Docket Nos. 50-269

Duke Power Company

In our meeting on March 23, 1977, at the Jocassee Dam site near the Oconee Nuclear Station, we stated what we consider to be appropriate actions for Duke Power Company to take to allow us to evaluate the potential seismic hazard at the Jocassee Dam.

## SHORT TERM REPORT

RECOMMENDED STATION LOCATIONS AT LAKE JOCASSEE

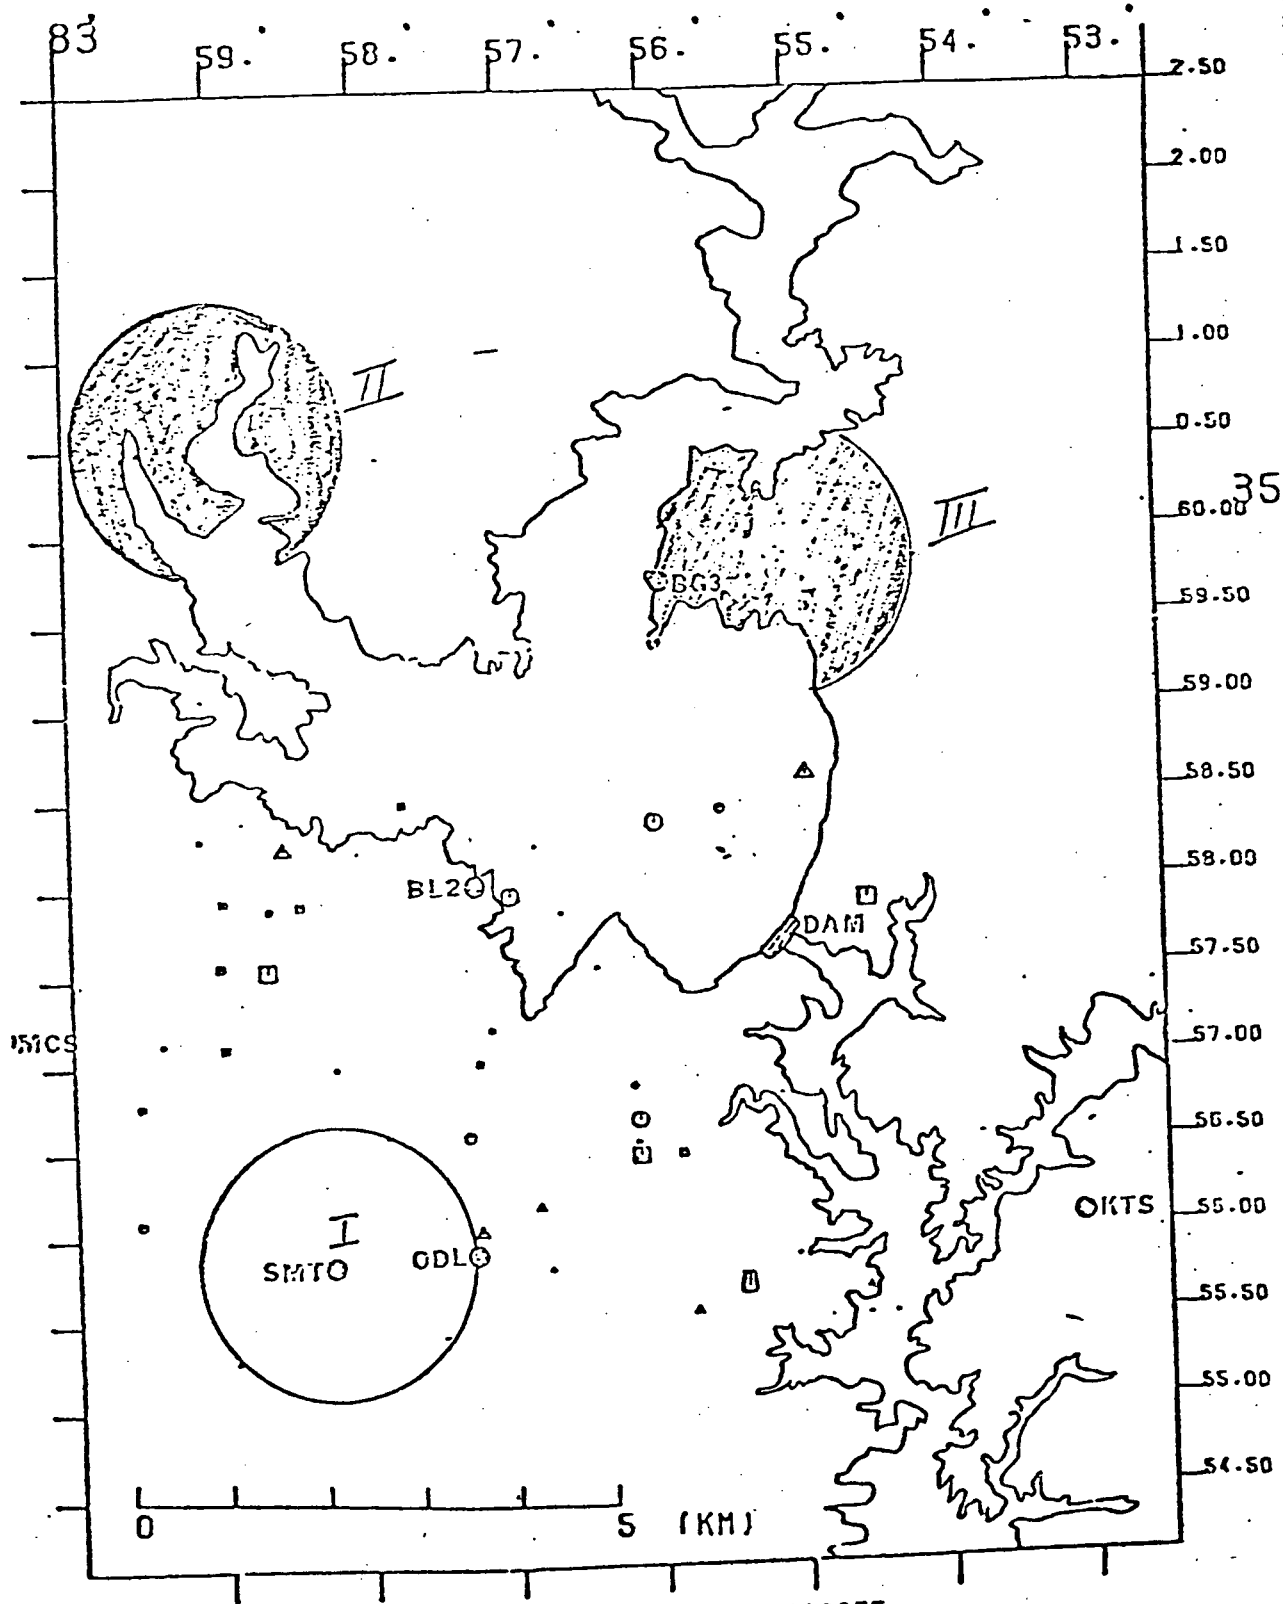
- (a) Seismic Stations: Until November 1978, three permanent stations should be operated by Duke Power and recorded at the damsite at that time a decision will be made, based on the level of activity up to November 1978, as to whether to continue the monitoring program. Two to four microearthquake recorders should be used to augment these stations until December 1977. At that time a decision will be made, based on the level of activity during 1977, as to whether to continue operation of the microearthquake recorders. The two

stations in addition to SMT should be installed as soon as possible. Suggested locations for these stations are shown in the attached figure. If possible, arrangements should be made with the USGS and USC to incorporate one or all of the Jocassee stations in the South Carolina network. This would allow recording of these stations on the delevelocorder at USC. If arrangements are made to include the stations in the network, it may be possible to use USGS radio frequencies for radio telemetry.
